Meeting Minutes: Plumbing Board

Date: Jan. 21, 2025
Time: 9:30 a.m.
Minutes by: Lyndy Logan
Location: Minnesota Room, DLI, 443 Lafayette Rd. No., St. Paul, MN 55155

D. **Variance Petition, Oak-Land Middle School – Larson Engineering (Attachments B & C)**

To: Minnesota State Plumbing Board Date: December 10, 2024
From: Larson Engineering, Inc. Project No: 12246044
Project: Oak-Land Middle School Additions & Renovations
Re: Variance Regarding 2020 Minnesota Plumbing Code Section 310.5

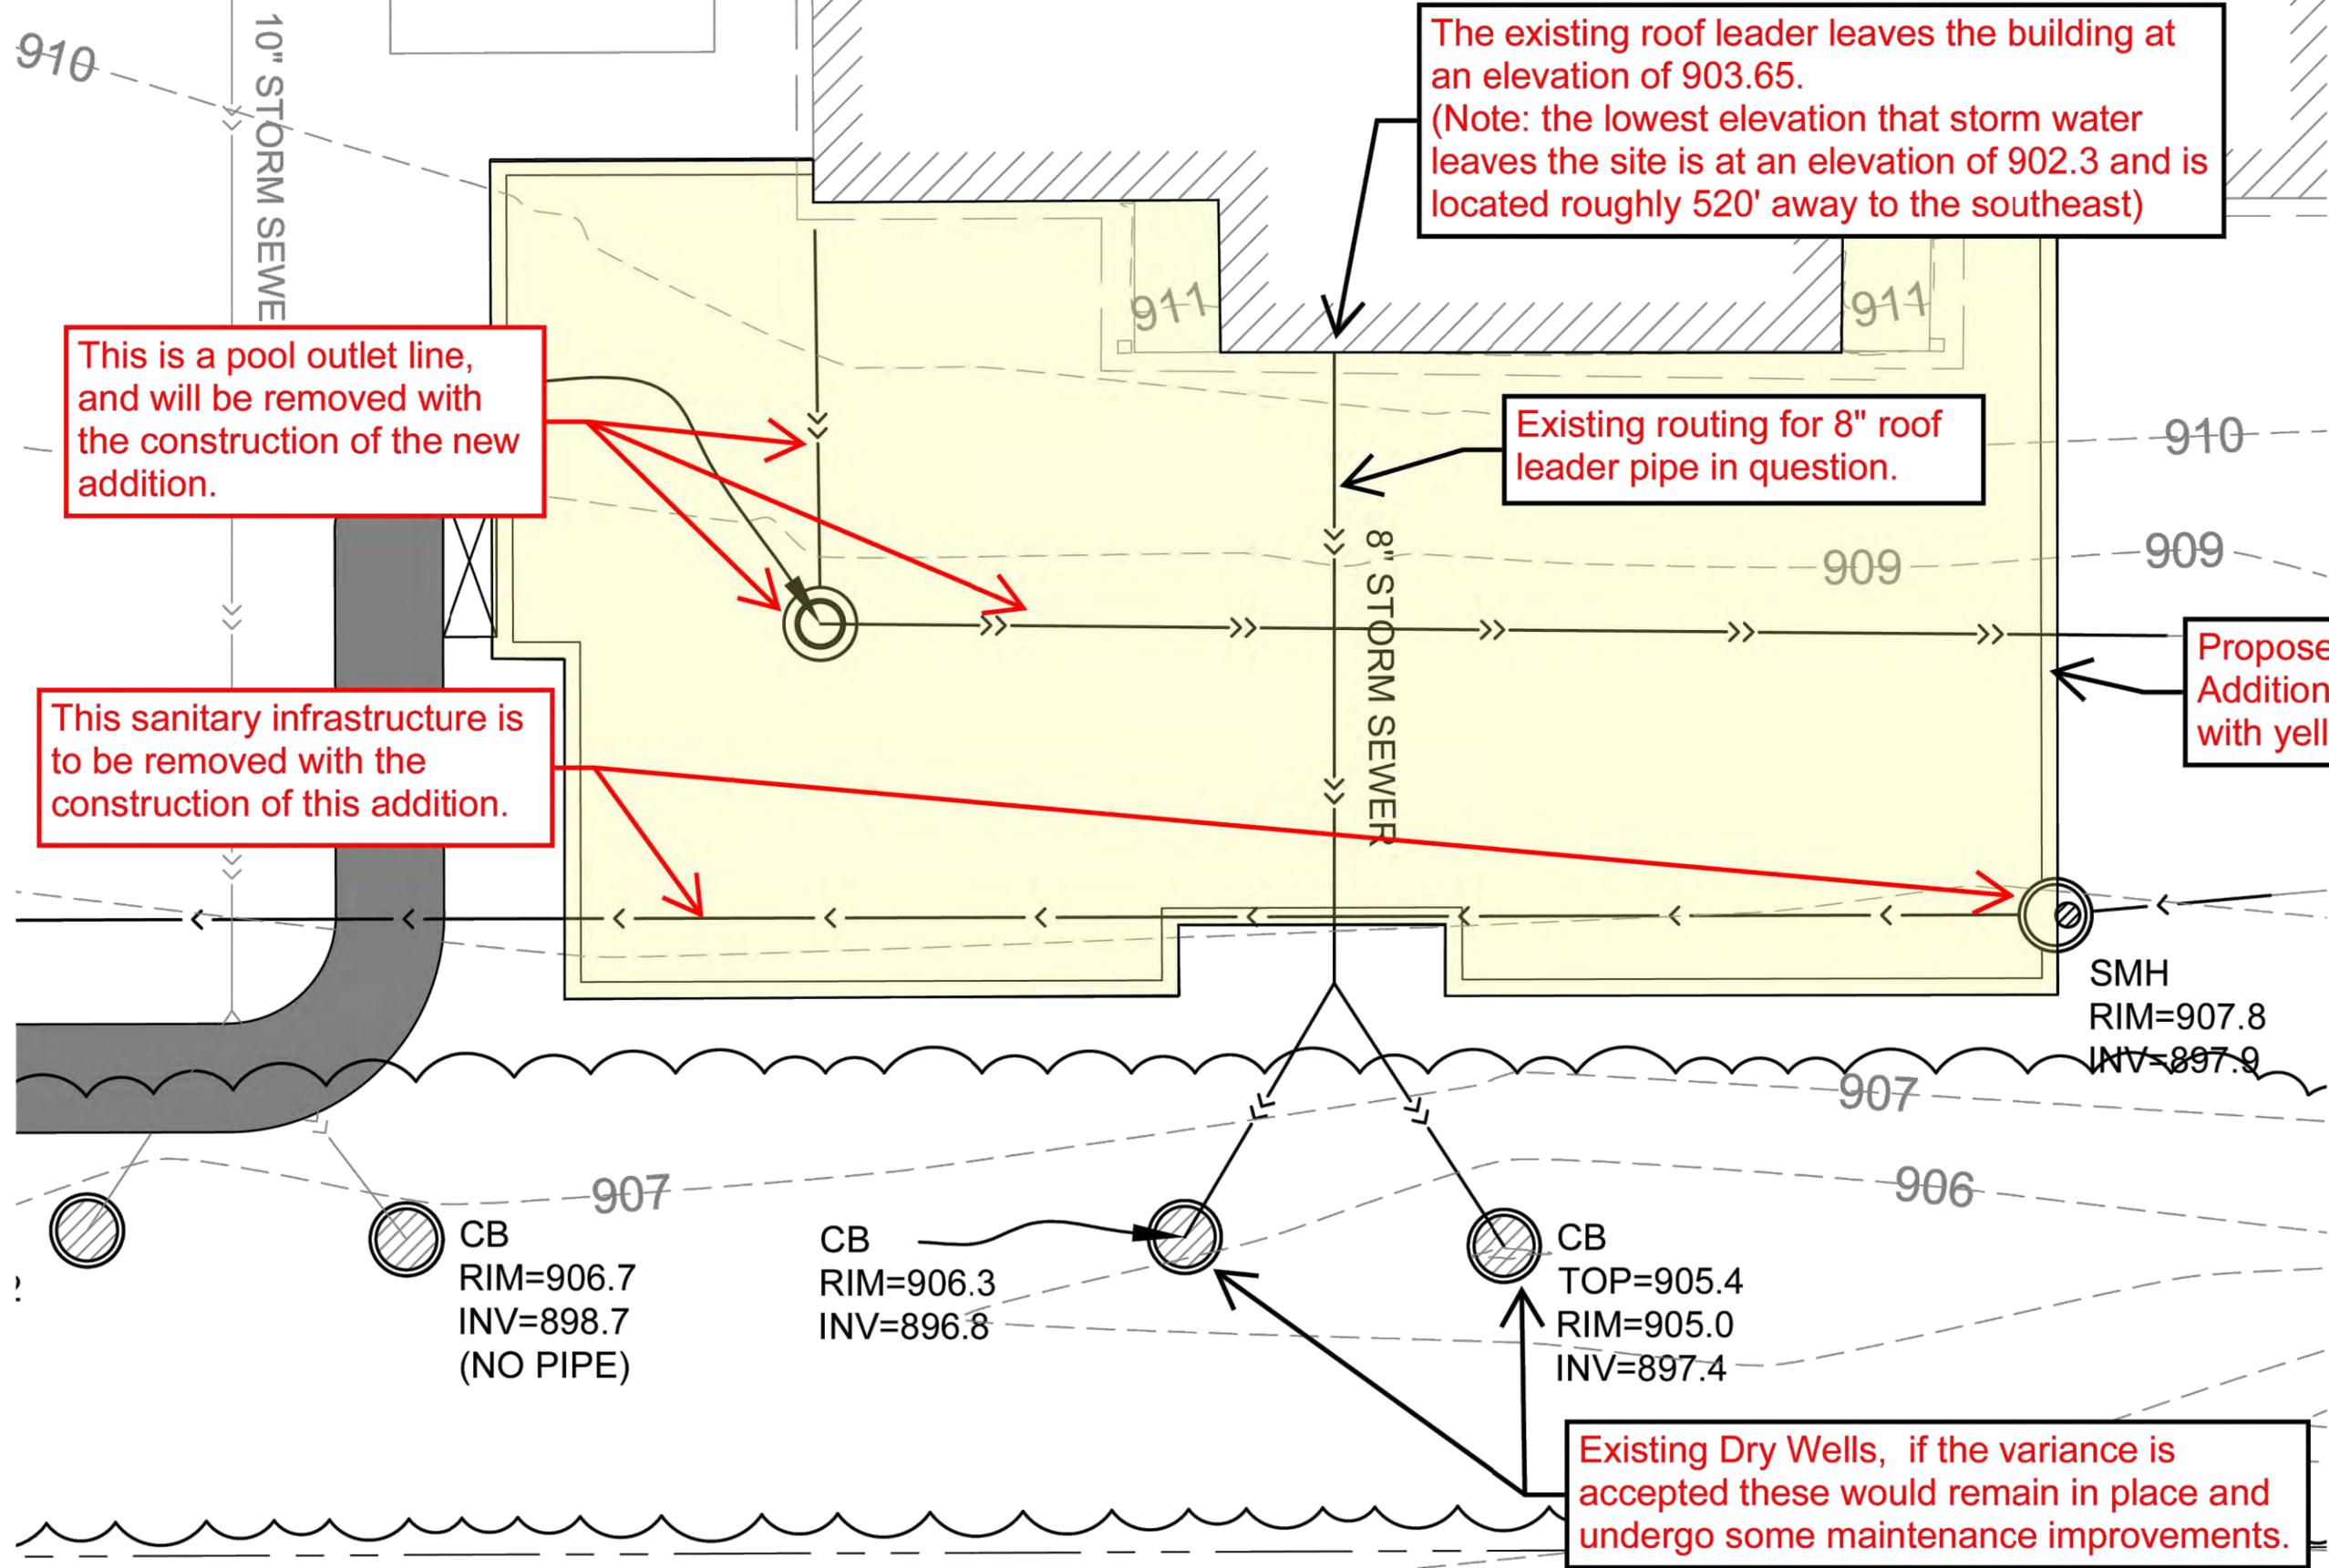
1. On the drawings can you please provide the water quality level for the dry wells? Can you explain how often the pipes will surcharge(what Rain event will it occur?) What rain event will the dry well overflow the manhole structure? **The water quality volume for the drywells is the volume between the Rim and bottom of the structure. That being said, the structures are 6' in diameter and one has a rim to invert height of 8'and the other has a rim to invert height of 9.5'. Therefore, the water quality volume provided in the 9.5' tall structure is about 267 CF and the water quality volume in the 8' structure is about 226 CF. Looking at the roof water in consideration of the typical civil engineering stormwater design standards, water draining from the roof to the drywells would overflow/cause surcharging of the pipe in all storm water events such as 2-yr (2 in) , 10-yr (4 in), and 100-yr (7 in). There are some unknowns about the original design of the existing dry wells that could affect our calculations such as the rate water dissipates from the drywell. Based on our current soil borings for the new addition, infiltration rates used for our stormwater design for the underlying soils are about 0.8-0.6 in/hr. Some areas of Lake Elmo have more rapid infiltration where the rates are up to 12-30 in/hr. I mention this because the site adjacent to ours has two rapid infiltration basins that were designed with the Valley Branch Watershed, so water could be dissipating from the drywells at a much higher rate. The manager of facilities and site operations for the Stillwater Area Public Schools has stated he believes the drywells only overflow in the event of larger rainfalls such a 1" – 2" events or greater. He has also worked with the district for over 25 year managing the facilities and there haven't been any significant issues with water surcharging in pipes interior to the building to his knowledge.**

2. Provide a larger site plan showing elevations of the storm system, helps explain why you cannot connect to existing. Show other work that will be completed on the site. **I have attached utility drawings to this email that depict the design if the drywells are maintained, but please note that the stormwater system for the site are rather complex and cluttered. This was initially withheld from the submittal to prevent confusion. The attached plan sheets are not the most recent utility plans for the project as the project is set to start construction this spring and we needed to proceed forward with an alternate design that included a lift station to service the existing roof leader which greatly increased the cost of the civil related work.**

4. Can you connect more of the existing roof to the new 10" RWL to reduce the surcharge or eliminate it entirely? Does this impact the amount of surcharged pipe in the building? Always try and minimize the impact if possible. Hallberg Engineering rerouted as much of the roof as possible to the new higher roof leader that goes to our underground stormwater treatment system. About 18% of the existing roof that drained to the existing roof leader was re-routed to the new roof leader. Based upon my response in item #1, it's hard to quantify exactly how much this reduction in roof area will help the surcharge of the existing drywells.

Existing routing for 8" roof leader pipe in question.

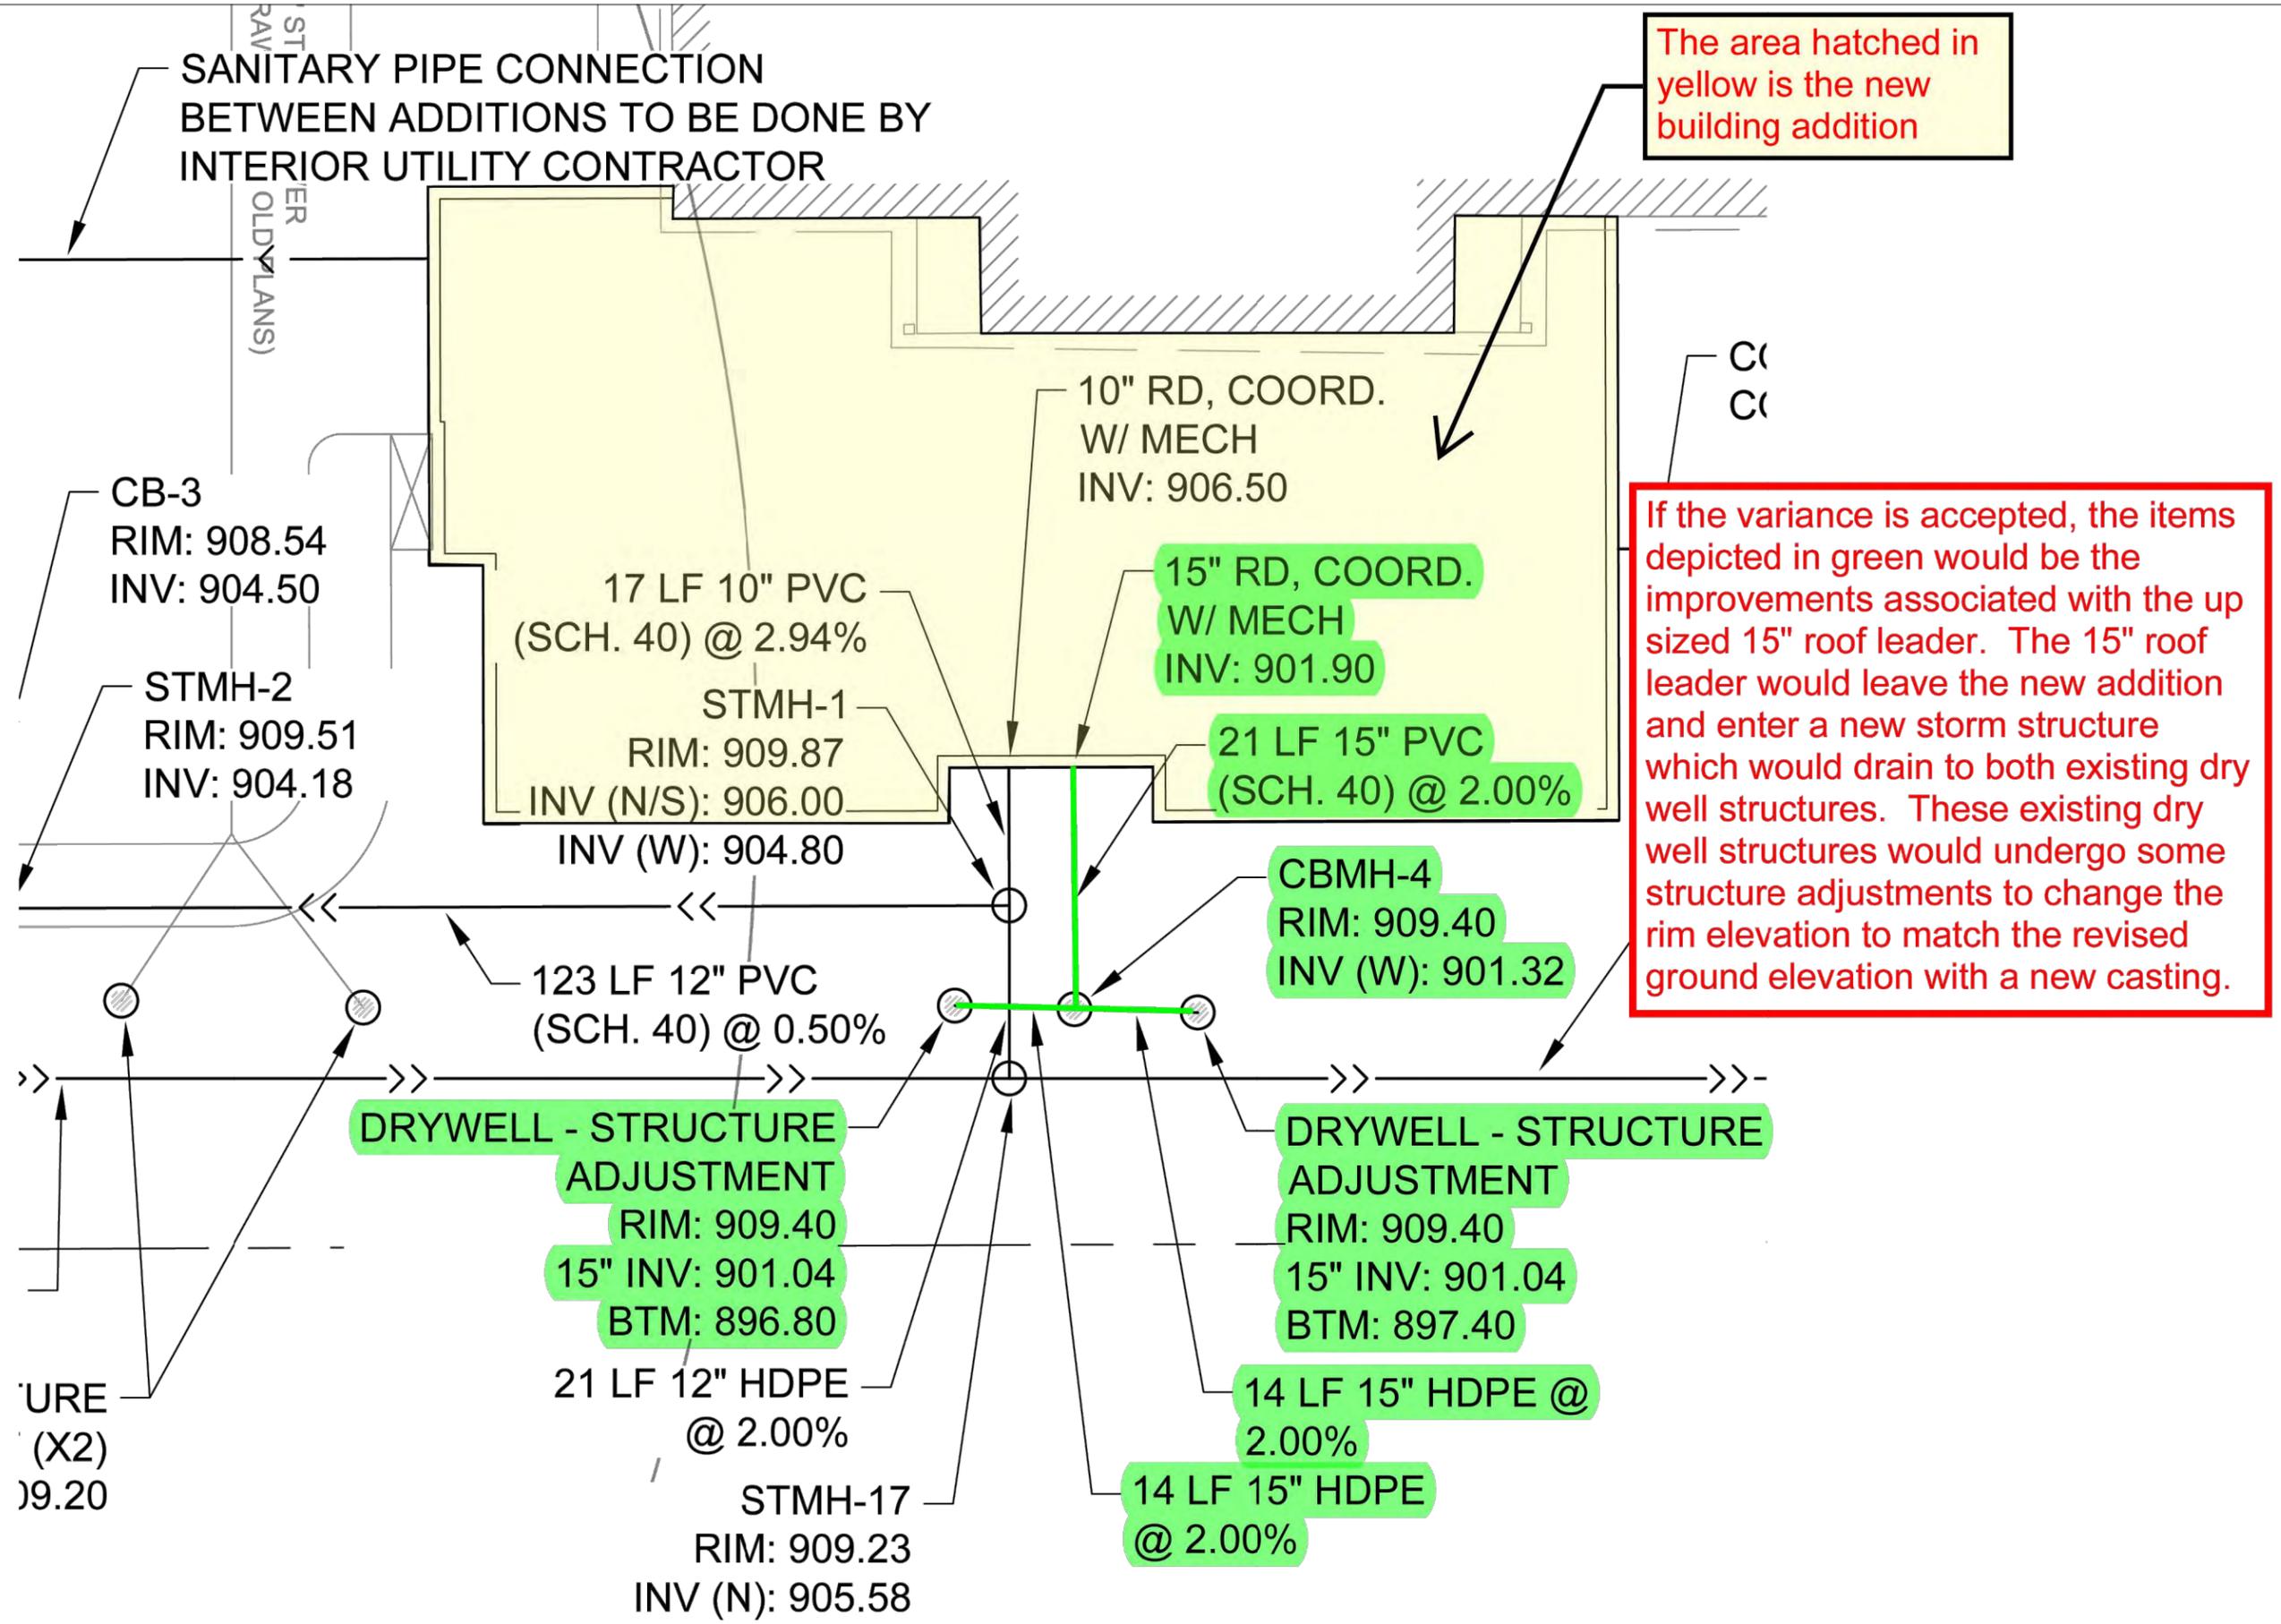
The existing roof leader leaves the building at an elevation of 903.65.
 (Note: the lowest elevation that storm water leaves the site is at an elevation of 902.3 and is located roughly 520' away to the southeast)

This is a pool outlet line, and will be removed with the construction of the new addition.

15" up sized roof leader, this services the existing roof and leaves the building at a significantly lower elevation (901.9)

PRIMARY EXTERIOR ISSUES

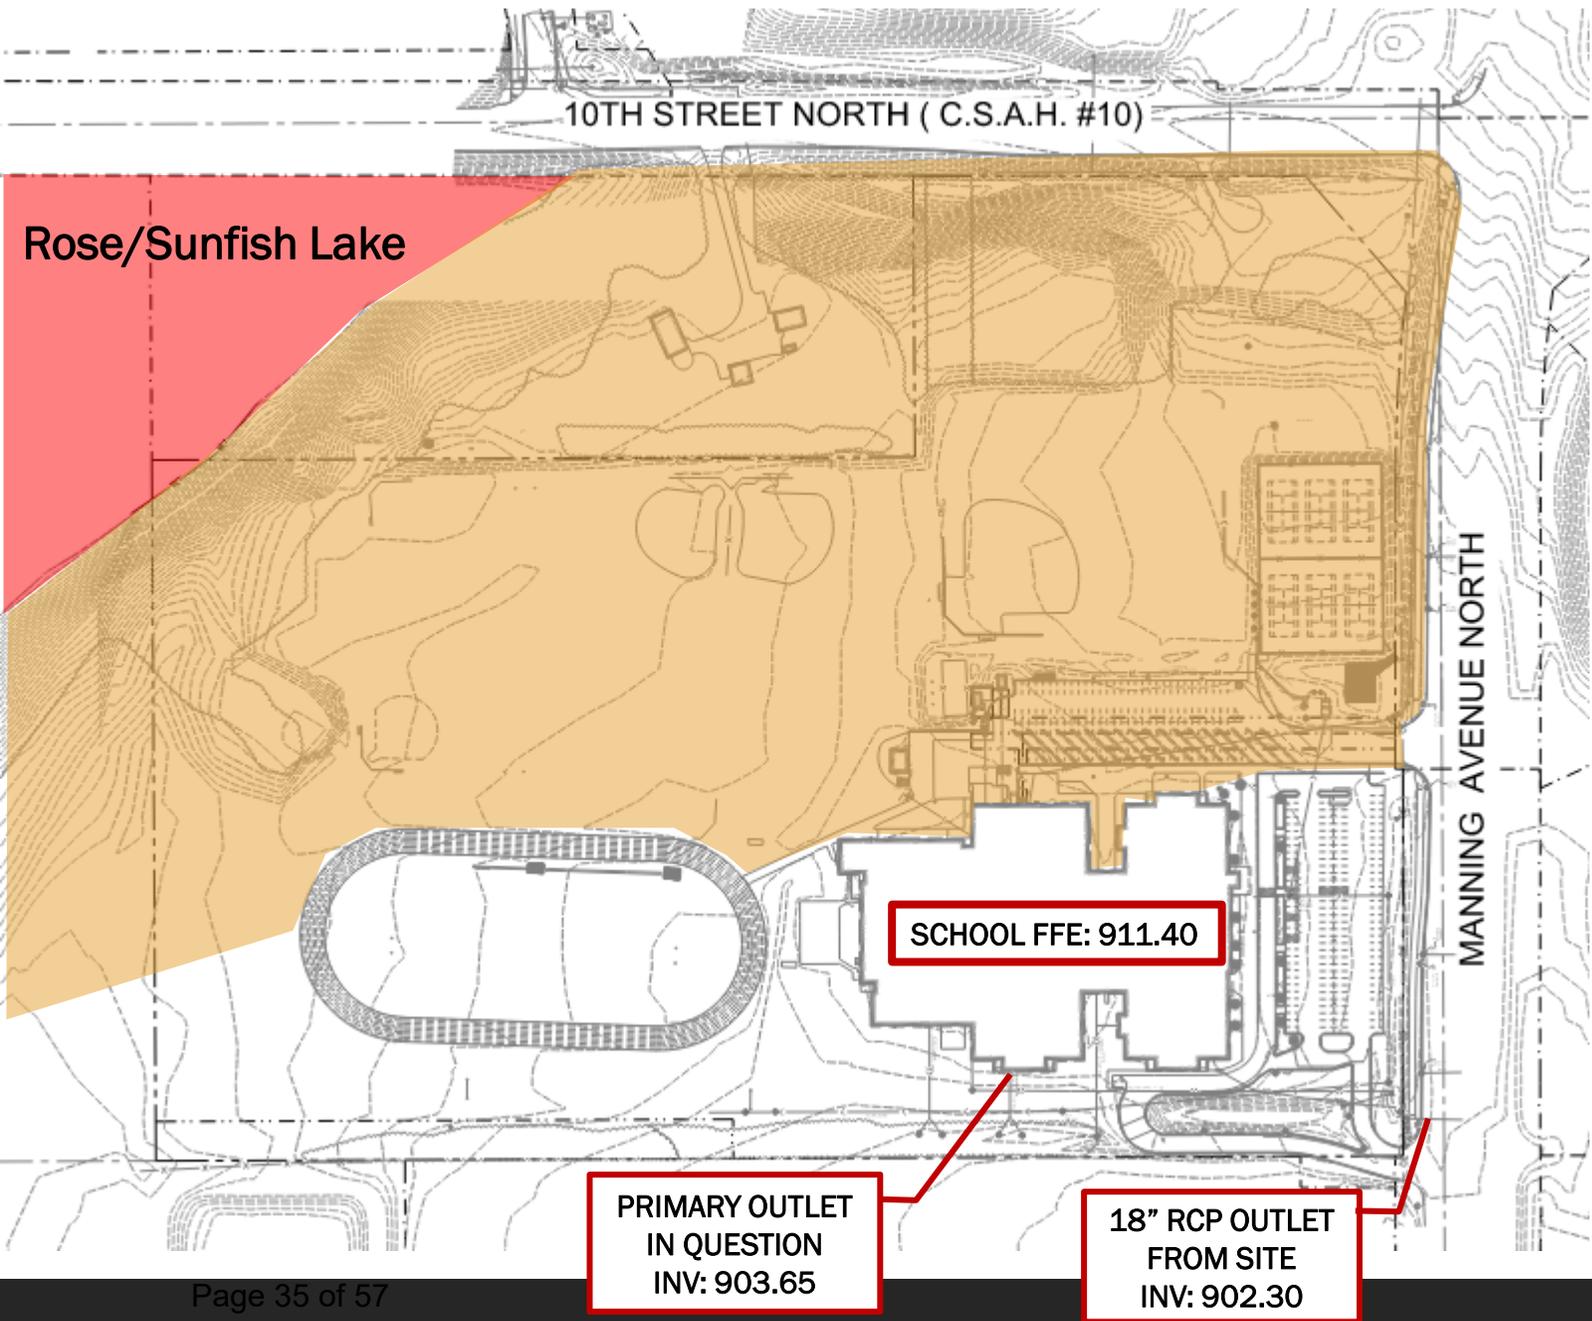
- EXTERIOR ELEVATION THE ROOF LEADER LEAVES THE BUILDING
 - BUILDING FINISH FLOOR ELEVATION = 911.40 (100' 00")
 - OUTLET ELEVATION = 903.65 (92' 3")
 - 7' 9" FROM FFE TO INVERT OF ROOF LEADER

- DRYWELLS WHERE NEVER DESIGNED TO PROVIDE WATER QUALITY VOLUME.
 - CURRENT DRYWELL SERVICING THE ROOF LEADER IN QUESTION PROVIDES ROUGHLY 200 CF OF WATER QUALITY VOLUME (WQV) WHICH WOULD BE SUFFICIENT FOR A ROOF WITH AN AREA 2,400 SF

- LACK OF LOCATIONS ON SITE WITH LOW ELEVATION.
 - ROSE/SUNFISH LAKE WATERSHED: CAN'T INCREASE RATES OR VOLUME TO THE LAKE IN ANY STORM EVENT.
 - LOWEST GRADE AT SOUTH PROPERTY LINE = 906.00

- LOW STORM INVERT LEAVING THE SITE = 902.30
- POSSIBLE OUTLET LOCATION IS JUST OVER 500 FEET FROM EXISTING ROOF LEADER CONNECTION POINT
